HARTING Product Change Notification

PCN/18/014/C+N

Product range: DC1 / D-Sub

Title: D-Sub hoods with straight cable entry and screw locking - External

(Image shows the 9-pole plastic hood and is for illustration purpose only)

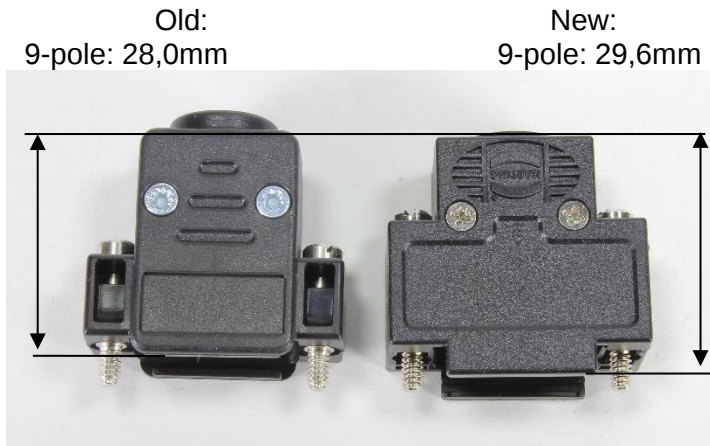
- Locking screw preassembly

Old: locking screw preassembled
in the cover

New: locking screw preassembled
in the hood
